MARKSHEFFEL ROAD (SOUTH)

STREET IMPROVEMENT PLAN

30% PLAN SET - MAY 2022

MARKSHEFFEL ROAD
(SOUTH)
COVER SHEET

MARKSHEFFEL ROAD CL PROFILE (1)
STA 56+00.00 TO 68+00.00

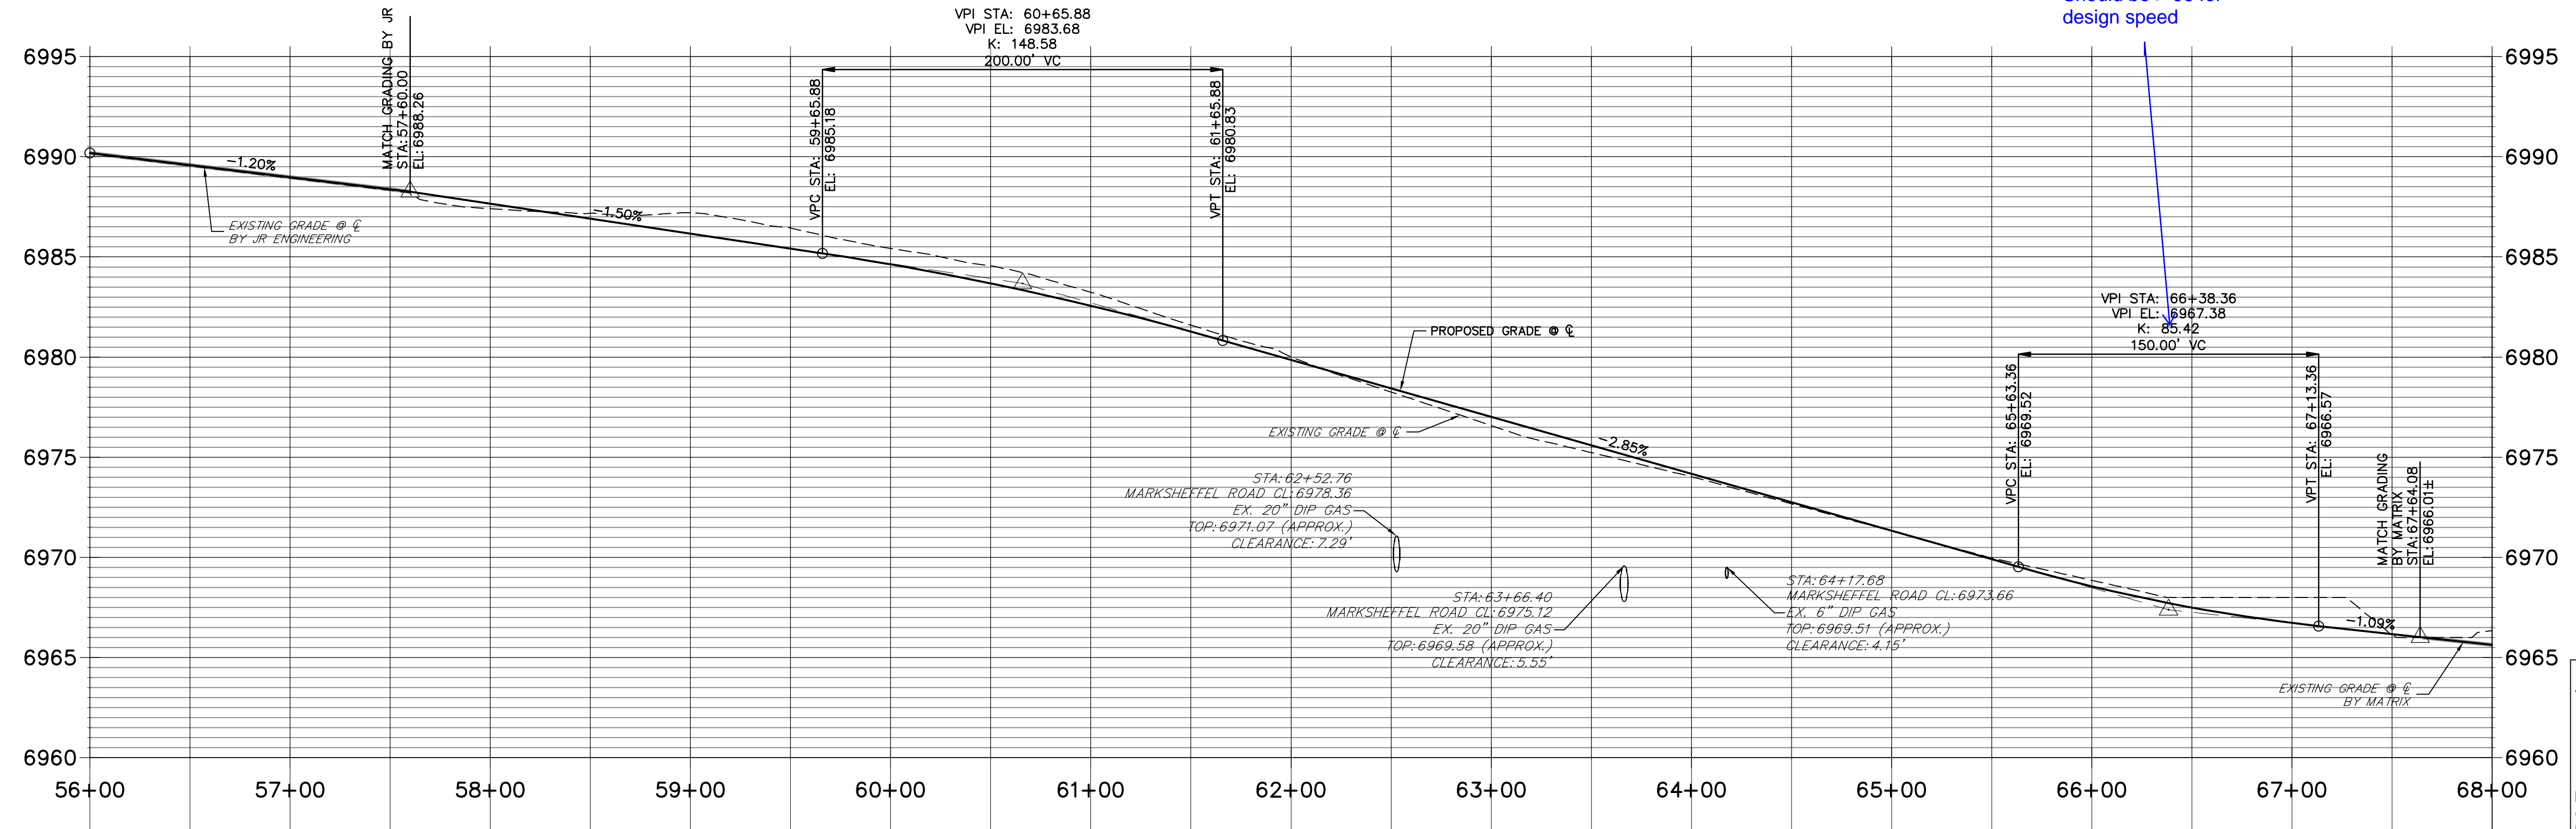
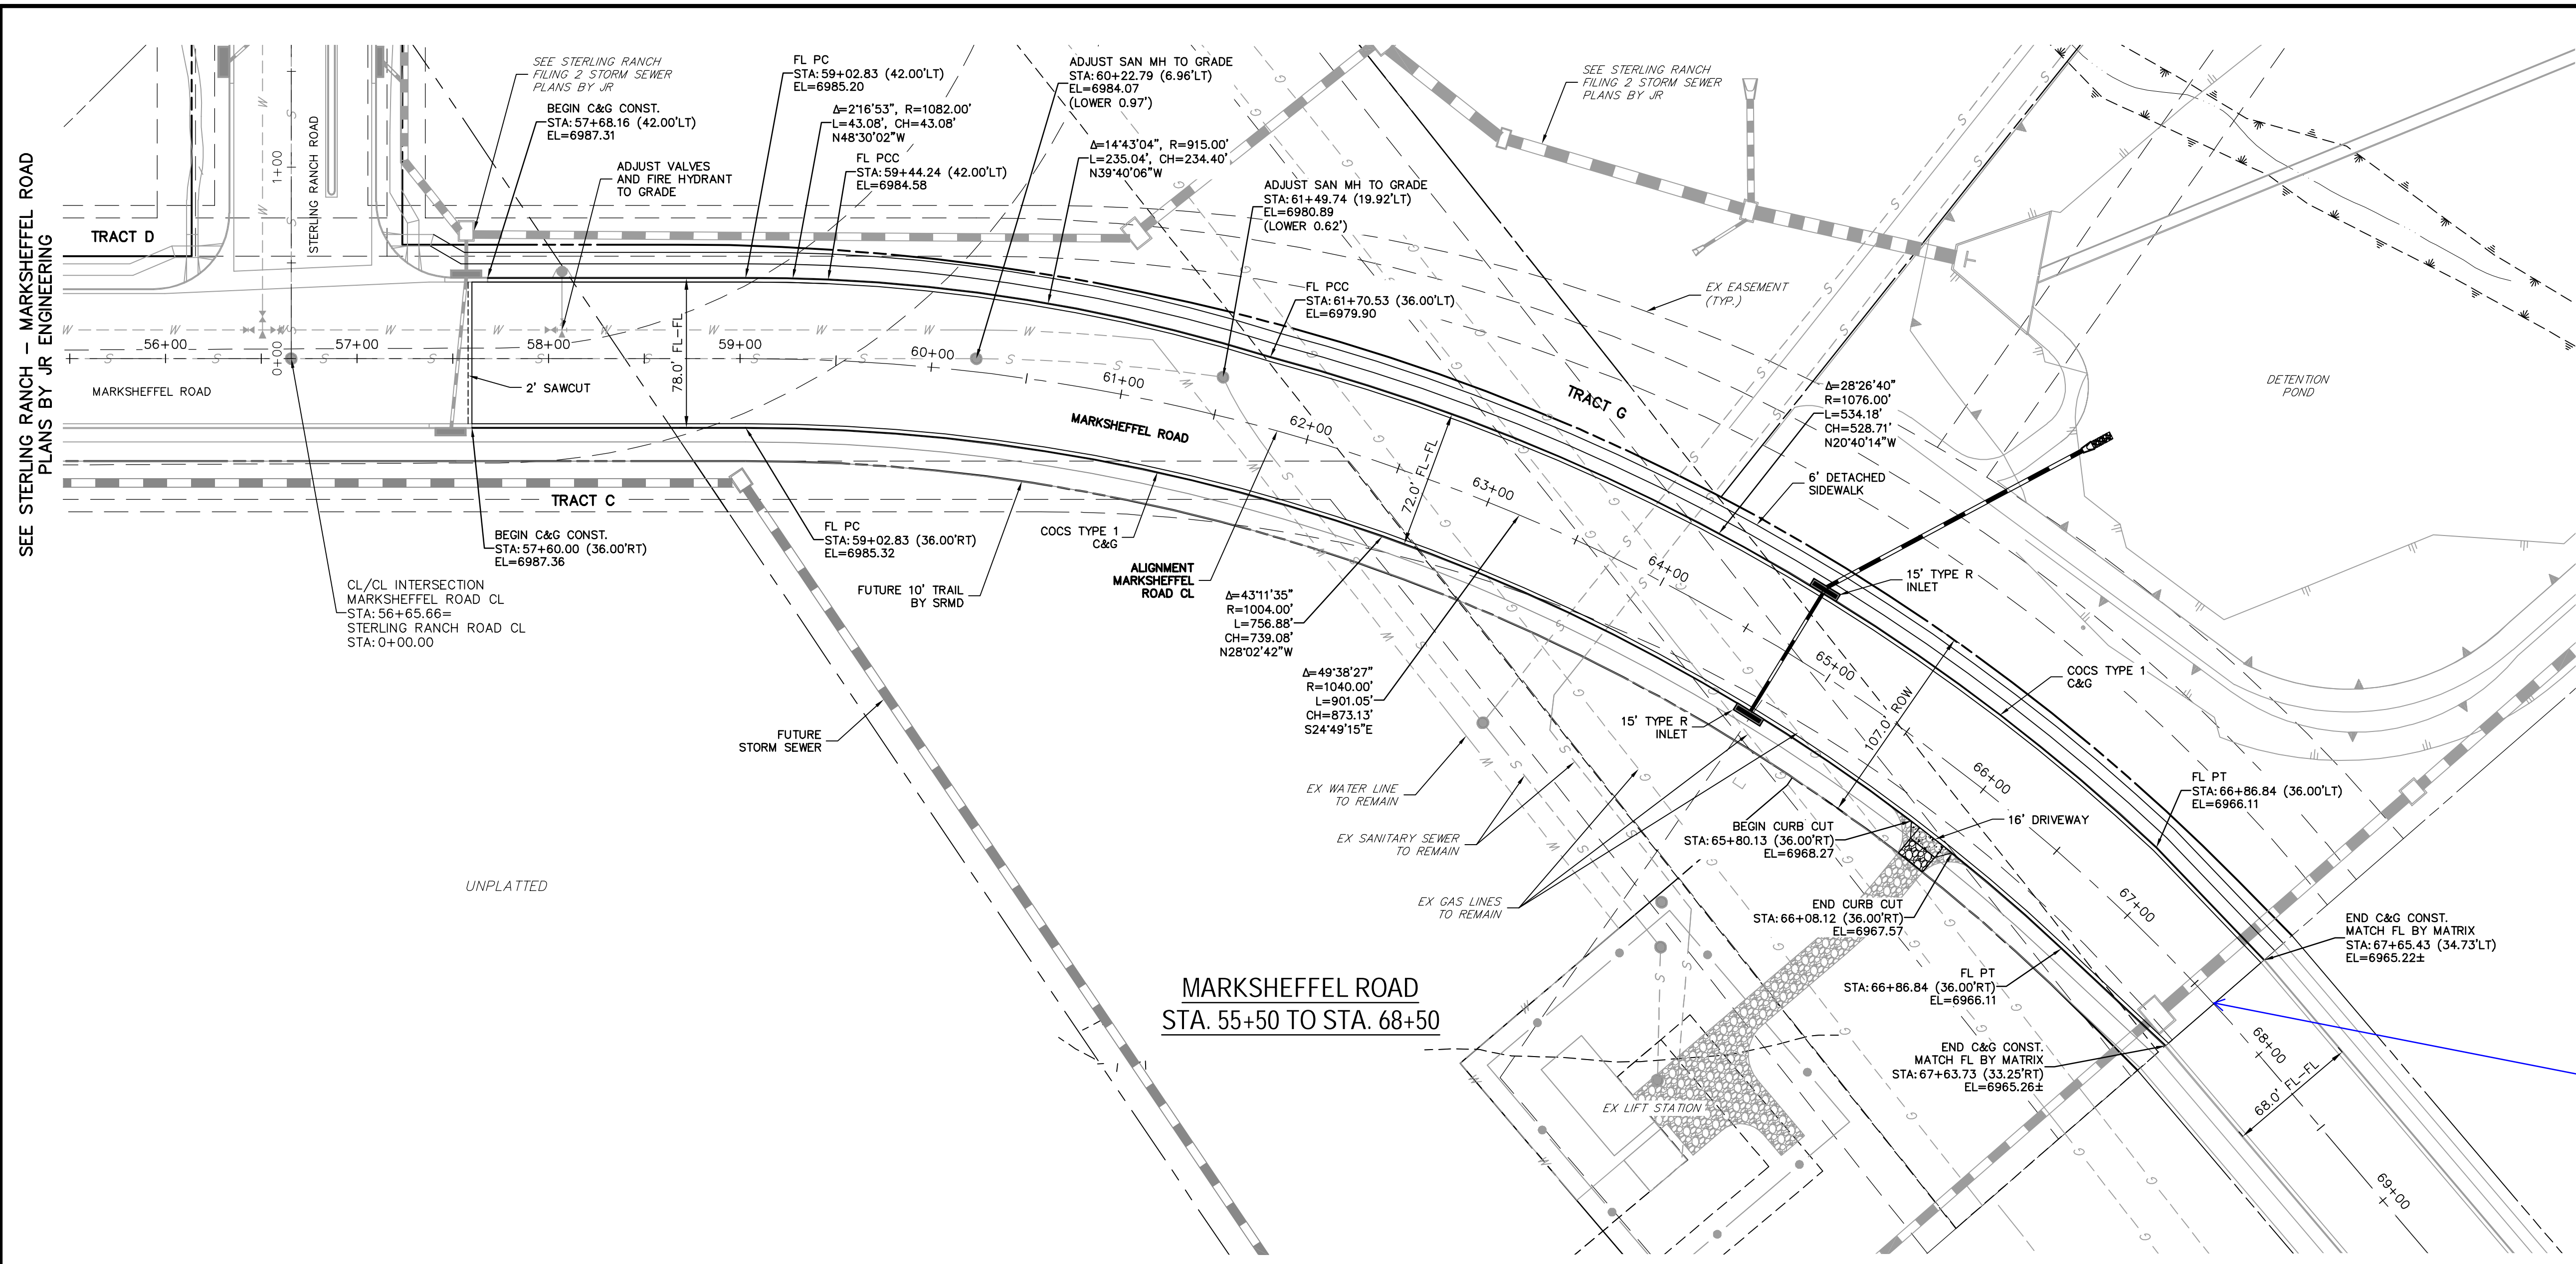
Provide centerline station and coordinates
